JAFP-17-0018
February 28, 2017

Subject: Eighth Six-Month Status Report in Response to March 12, 2012 Commission Order Modifying Licenses with Regard to Reliable Spent Fuel Pool Instrumentation (Order Number EA-12-051)

James A. FitzPatrick Nuclear Power Plant
Docket No. 50-333
License No. DPR-059

**James A. FitzPatrick Nuclear Power Plant's (JAF's) Eighth Six-Month Status Report for
the Implementation of Order EA-12-051, Order Modifying Licenses with Regard to
Requirements for Reliable Spent Fuel Pool Instrumentation**

POOL LEVELS AND REFERENCES

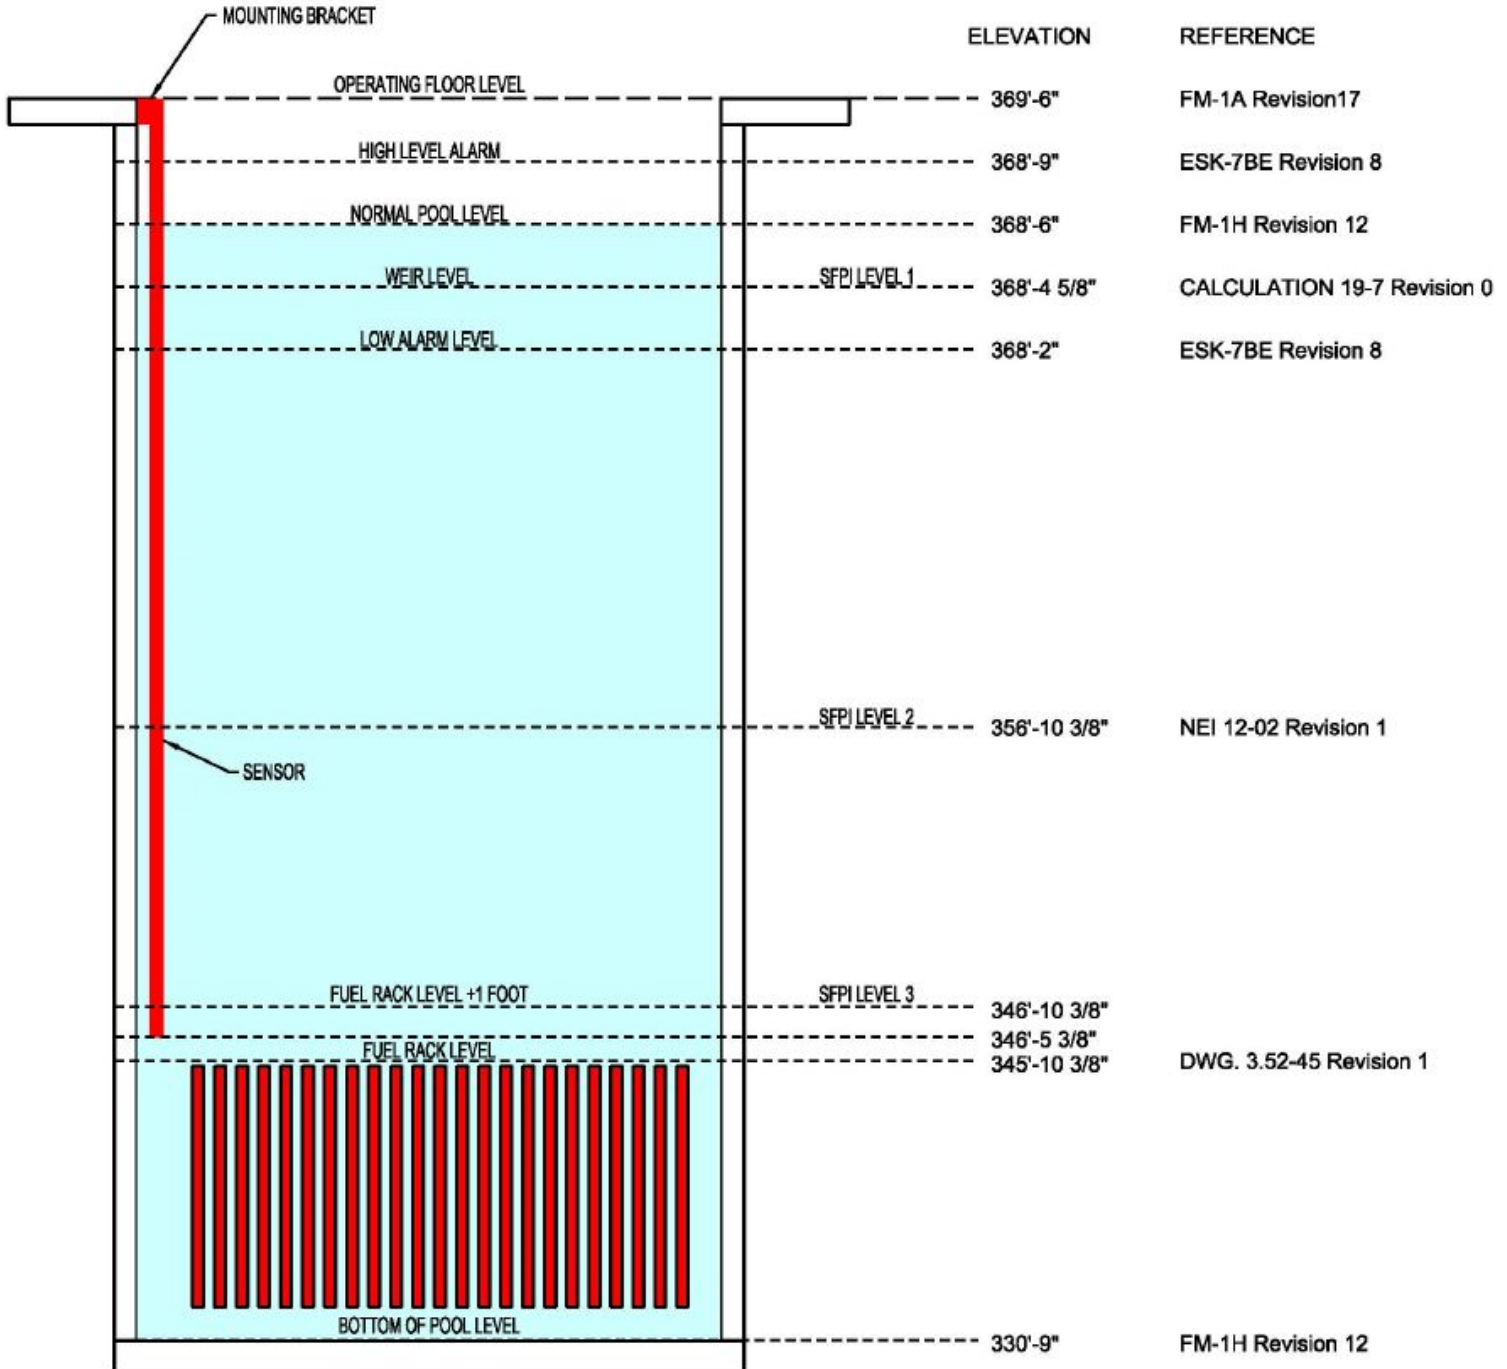
The final SFPI design makes several minor dimension changes to the probe elevation and level designations, which are captured in ECN 67191 (Reference 16). The revised probe elevation resolves a discrepancy of 1" between the specified procurement flange elevation and the as-built flange elevation. Bracket mounting calculation JAF-CALC-15-00005 (Reference 15) was reviewed and is still bounding.

SFPI Level 3 is now defined as 1' above the fuel racks (346'-10 3/8"), for consistency with the Entergy fleet. It was previously defined as 6" above the fuel racks during the design phase. Subsequently, Level 2 is now defined as 10' above the Level 3 definition (11' above the fuel racks). All elevations meet the NEI 12-02 guidance for Levels 2 and 3.

The elevation of the bottom of the probe based on the as-built flange height and final SFPI Levels 1, 2, and 3 are included in the figure below.
